STAFF RECOMMENDATION
1521 Fatherland Street
October 21, 2015

Application: New construction—infill; Setback determination
District: Lockland Springs – East End Neighborhood Conservation Zoning Overlay
Council District: 06
Map and Parcel Number: 08313040400
Applicant: John Root
Project Lead: Melissa Sajid, Melissa.sajid@nashville.gov

Description of Project: The applicant proposes to construct a new two-story house on a vacant lot. The request includes a setback determination to reduce a portion of the side setback on South 16th Street from ten feet (10') to seven feet (7'). The garage shown on the site plans is not a part of the current request.

Figure 2. 1521 Fatherland Street, proposed street facing side façade

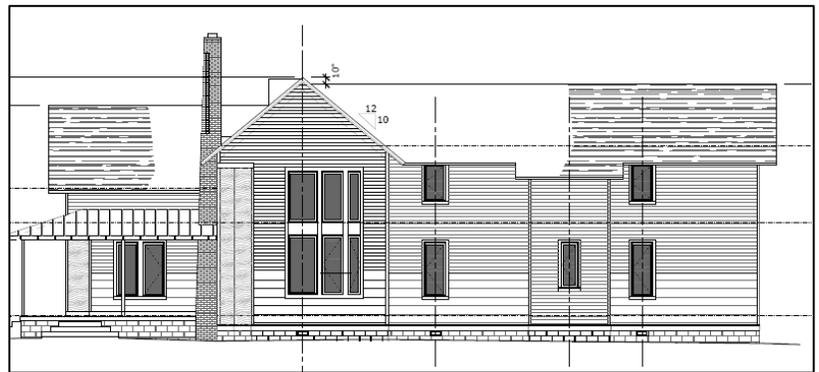
Height & Scale: The proposed building is two stories and twenty-eight feet (28') tall from the finished floor. The foundation height ranges from approximately twelve inches (12") to twenty-four inches (24") at the front. Homes in the immediate context range between sixteen and twenty-eight feet (16'-28') from grade. Although the overall height can be appropriate, the scale of the building is as a two-story building with eave heights of a two-story building where the majority of the historic context has the massing of one and one and one-half story homes. There is just one historic two-story home in the adjoining block of Fatherland; otherwise there are none between the 1800 block and the 1100 block where there is a series of four newer two-story buildings, constructed in an area with minimal historic context.

There is an existing church across South 16th Street that is two stories and thirty-five feet (35') tall; however, this is not a residential structure and not typical of the residential scale in the area. Staff finds that the proposed two-story house is not appropriate as it is not compatible with the residential context in the area. Furthermore, the infill is proposed for a corner lot, and the scale of the house from South 16th Street overwhelms the existing residential context (See Figure 2).

While the overall height of the house does not exceed the height context of the immediate area, staff finds that the proposed two stories is not compatible with the scale of surrounding historic buildings. The scale of the proposed infill will have a dramatic visual impact, especially given that the site is located at a corner lot. While there may be several taller, two-story buildings in the area, these buildings are not typical of the existing residential context. For these reasons, staff finds that the project does not meet section II.B.1.a. and b. of the design guidelines.
